**Subject:** Proposed Malvern St connection for I-90 Allston Interchange project

**RE: EOEEA #15278 I-90 Allston Interchange Project DEIR**

#### Grand Junction Urban Rail and Transit context

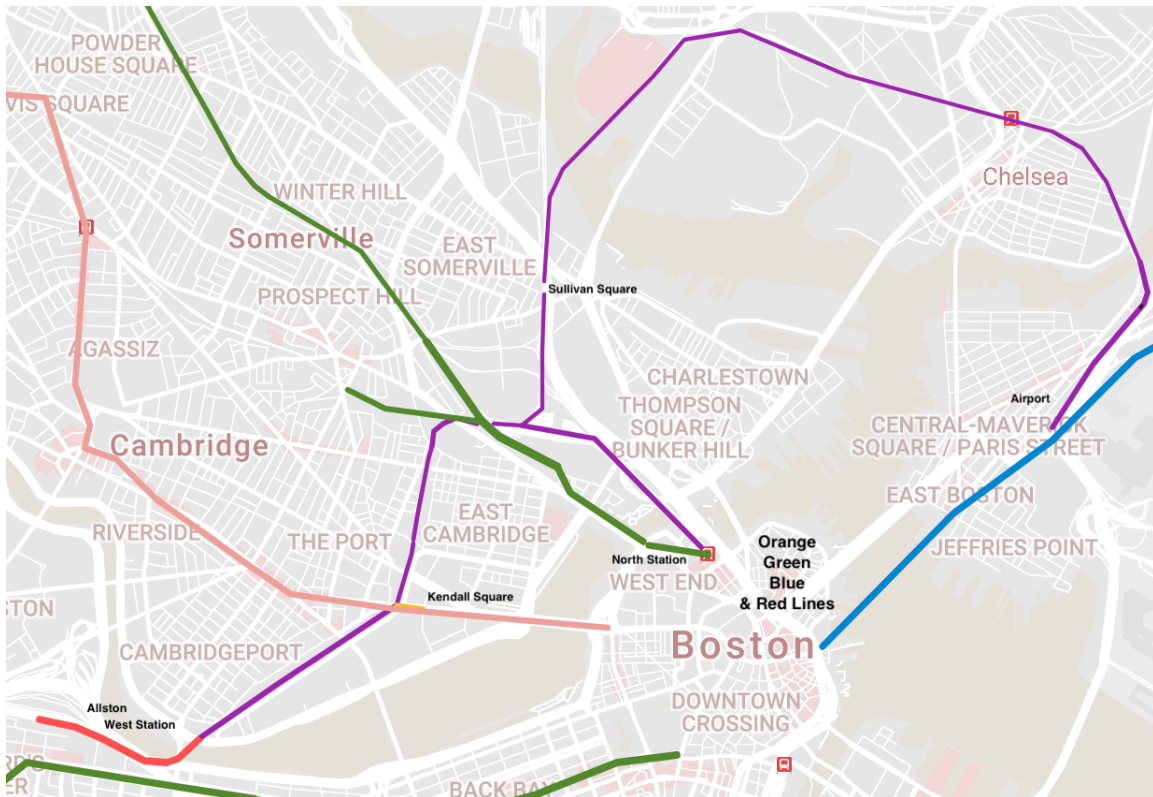
We ask that MassDOT includes and specifies sufficient width for passenger rail trackage on the Grand Junction corridor from the future West Station area to the “throat” area. FGJ-5
